# Conceptual Review Agenda

Schedule for 02/04/13 to 02/04/13

# 417 N Grant Ave Subdivide & SF Homes

# I-25 & Carpenter Rd

**STORE #317 - FORT COLLINS, CO**  
 I-25 & CR32  
 CONCEPT PLAN

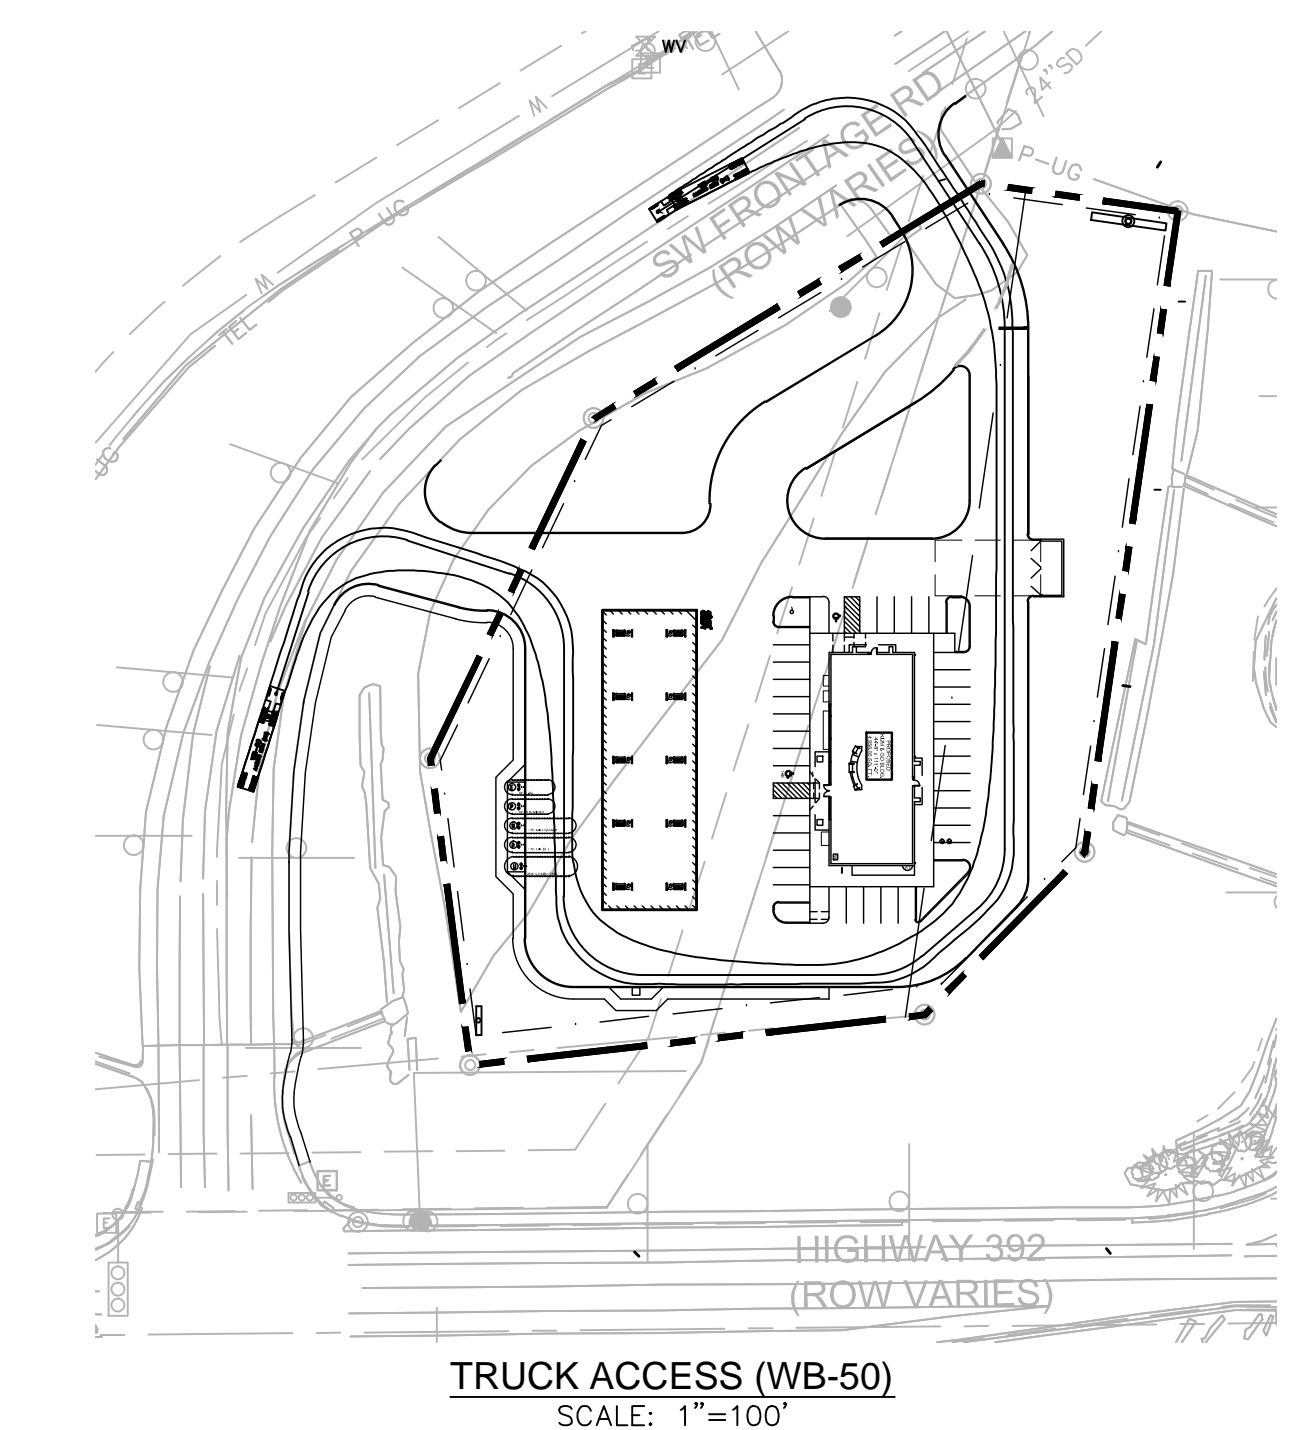
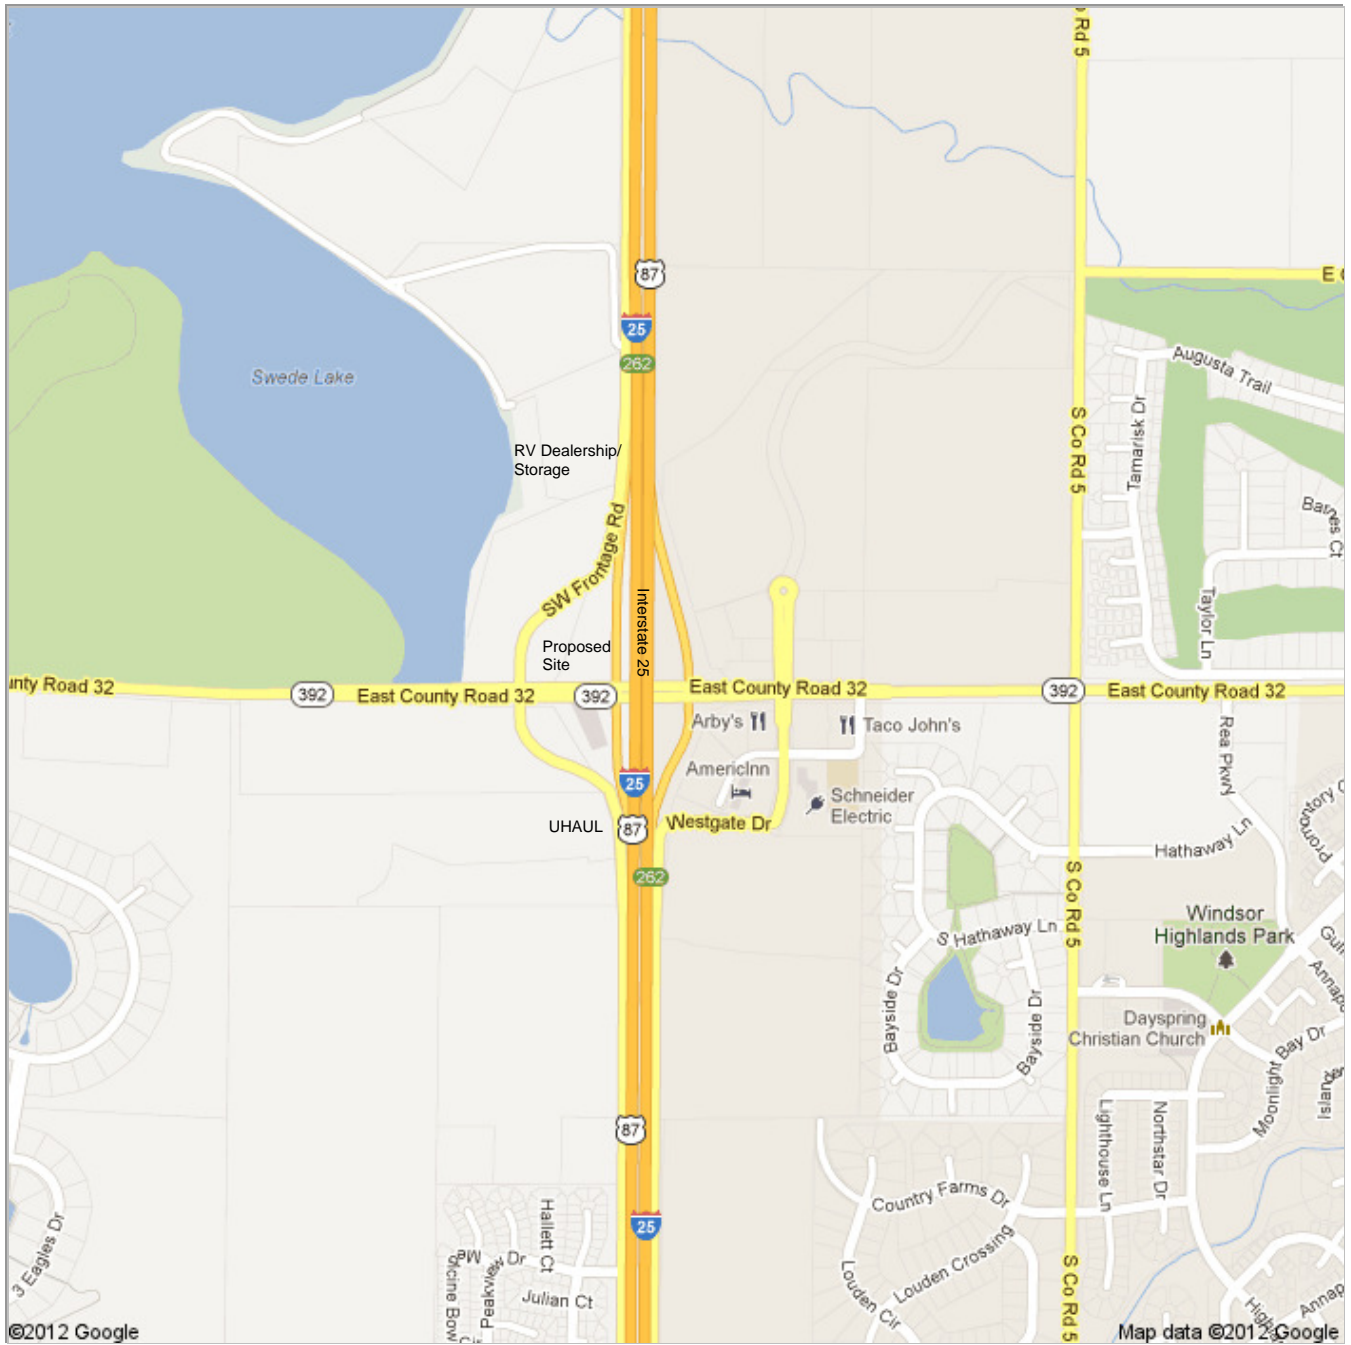
2. The site is 2.84 acres in size. The proposed site plan appears to leave a significant portion of the site vacant or under-utilized. While there will be land area devoted to stormwater detention and water quality, there remains land area that would appear to be beneficial if improved appropriately. The applicant is encouraged to consider providing an additional viable land use or an outdoor dining area, patio, picnic shelter, dog exercise area, playground or other features that would serve the traveling public and make better utilization of the available land area. For example, what is the proposed use for the large island north of the building? Note that there are striking views of Long's Peak. Perhaps an amenity package that acts as a rest stop with views to the southwest would be attractive to customers. Perhaps the location of the canopy can be adjusted to accommodate this view.

3. As mentioned, the building is surrounded by parking and drives. This precludes a direct connecting walkway that links the building to the public street system that includes a bike lane and will, upon development of this parcel, a public sidewalk. Please note that the schematic plan sent by Jessica Bowser via pdf on December 12, 2012 does a better job of relating the building to the Frontage Road than the current version. If a site plan cannot be arranged to provide this connecting walkway, then the applicant will need to seek a Modification of Standard. Please refer to Section 2.8 for the criteria by which the Planning and Zoning Board may approve or approve with conditions, a Modification of Standard.
